**RE: SUPPLEMENTAL REMEDIAL ACTION WORK PLAN ADDENDUM
SUN CHEMICAL, SITE #C243024
441 TOMPKINS AVENUE, STATEN ISLAND, NEW YORK**

PROPOSED SOIL SAMPLING AT
SUN CHEMICAL SITE AND AT
84 CHESTNUT AVENUE

PLATE
3

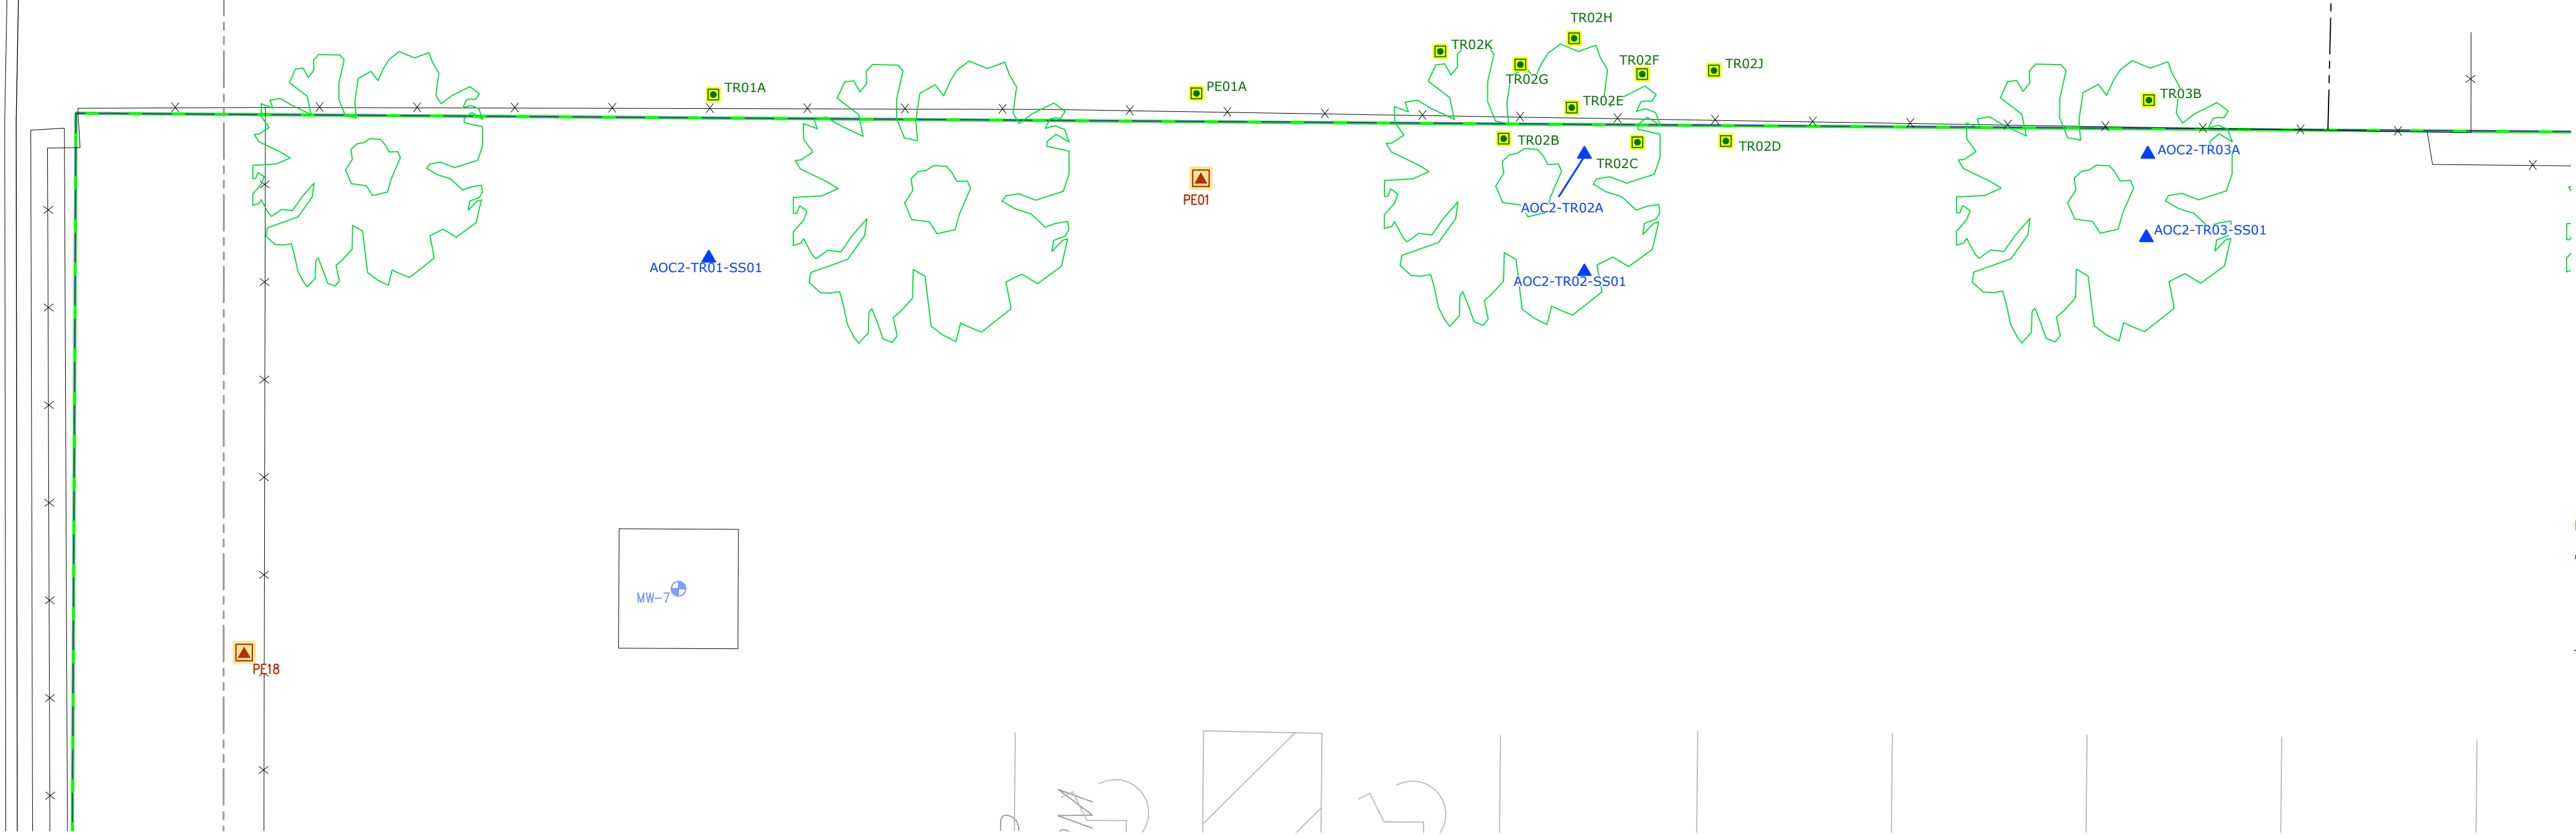
1. Further delineate the on-site lateral extent of PCB concentrations above the residential SCO near location AOC2-TR02A. As indicated on the attached Plate 3, analytical data from the adjacent documentation samples collected to date in this portion of AOC 2 (i.e., AOC2-PE01 and AOC2-TR03) show only non-detect PCB results, suggesting that the lateral extent of the exceedance at AOC2-TR02A is minor. Accordingly, to further refine our understanding of residual PCB concentrations on-site, Sun Chemical proposes to confirm the PCB concentration at TR02A via collection of an additional soil sample from 0-2" and to evaluate the vertical extent of PCB impact through collection of deeper samples from 2-12" and 12-24". In addition, Sun Chemical also proposes to complete two additional documentation sampling points, TR02B and TR02C, along the eastern property boundary approximately 3 feet north and south of AOC2-TR02A. Surface soil samples, from 0-2" below any surface backfill material that may have been placed above unexcavated soils for grading purposes, will be collected for PCB analysis. Contingency vertical delineation samples will also be collected from 2-12" and 12-24" from each location, and will be analyzed for PCBs if the corresponding surface result exceeds the residential SCO. In addition, as shown on the attached plate, contingency lateral delineation boring AOC2-TR02D will be completed approximately 6 feet south of AOC2-TR02A. Soil samples will be collected from 0-2", 2-12" and 2-24" and analyzed if needed to better define the boundaries of any impacts identified at AOC2-TR02C. Given that soils were excavated to a depth of 2 feet south of TR02A as part of the larger remedial activity in AOC 2, no delineation sampling is proposed in that direction. Similarly, contingency sampling is not proposed north of TR02B as surface and near-surface materials at that location are now comprised of clean backfill.

2. Evaluate constituent concentrations potentially present at the adjoining property. As shown on Plate 3, six soil borings (AOC2-TR02E, F, G, H, J and K) are proposed in the estimated 5-foot-wide walkway located between the house and the shared property boundary. Each of these borings will be completed manually (hand auger). Soil samples will be collected from the soil surface (0-2"), as well as from 2-12", 12-24" and 24-30". The soil samples will be analyzed in a staged manner, beginning with the surface (0-2") samples from AOC2-TR0E and AOC2-TR0F, and proceeding laterally and/or vertically per the approach for the proposed on-site sampling, as needed to document the extent of any constituent concentrations above the residential SCOs.

Further, as requested in the December 8, 2017 comment letter, three off-site borings will be completed due east of previous on-site sampling points PE01, TR01 and TR03A. Accordingly, as shown on Plate 3, off-site locations PE01A, TR01A and TR03B will be completed east of those prior on-site sampling points. As with all other soil borings proposed herein, soil samples from these three hand-auger borings will be collected from the soil surface (0-2"), as well as from 2-12", 12-24" and 24-30". The soil samples will be analyzed in a staged manner, beginning with the surface (0-2") samples and proceeding vertically as needed to document the extent of any constituent concentrations above the residential SCOs.

Last, in addition to PCBs, per the December 8, 2017 letter noted above, all of the initial proposed off-site soil samples will also be analyzed for Target Compound List PAHs as well as six metals (arsenic, barium, cadmium, chromium, lead and nickel). Contingency samples will be analyzed for any of those constituents identified above SCOs in overlying sampling intervals and/or from the same depth interval at adjacent soil borings.
